SCHEMATIC DIAGRAM FOR SILVERTONE CHASSIS 528.171-1

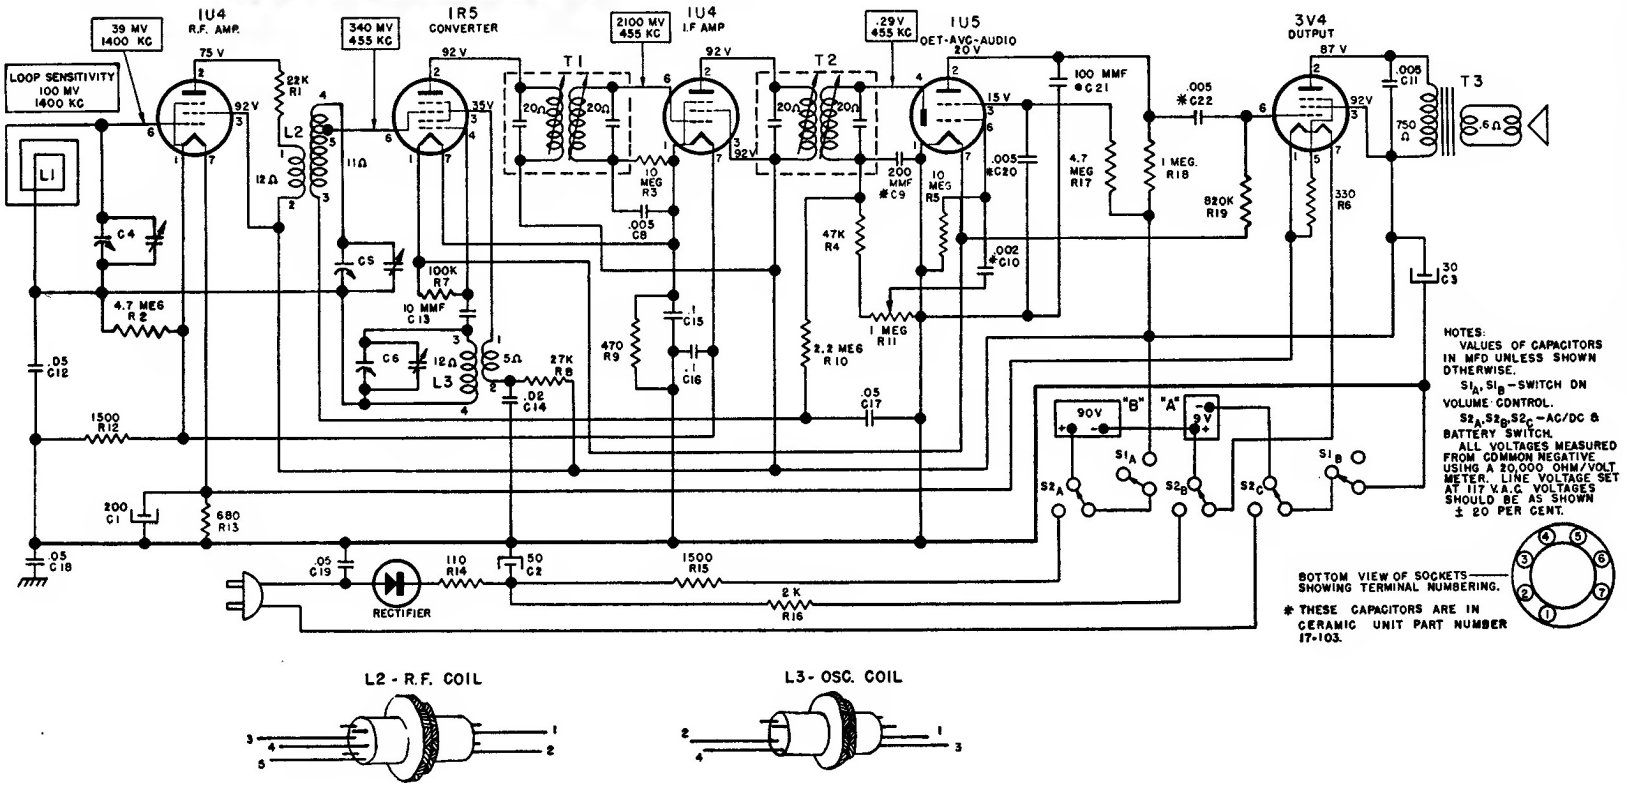
Chassis 528.171-1 is the same as 528.171 except for the Battery/AC/DC changeover system. The hand-operated switch is replaced by a type which is operated by plugging the power cord into a chassis socket. The socket is near the back edge of the chassis. There is a slot for only one prong of the power cord plug; the other prong hangs over the back apron. The detachable power cord and the socket for it on the chassis are replaced by a conventional power cord.
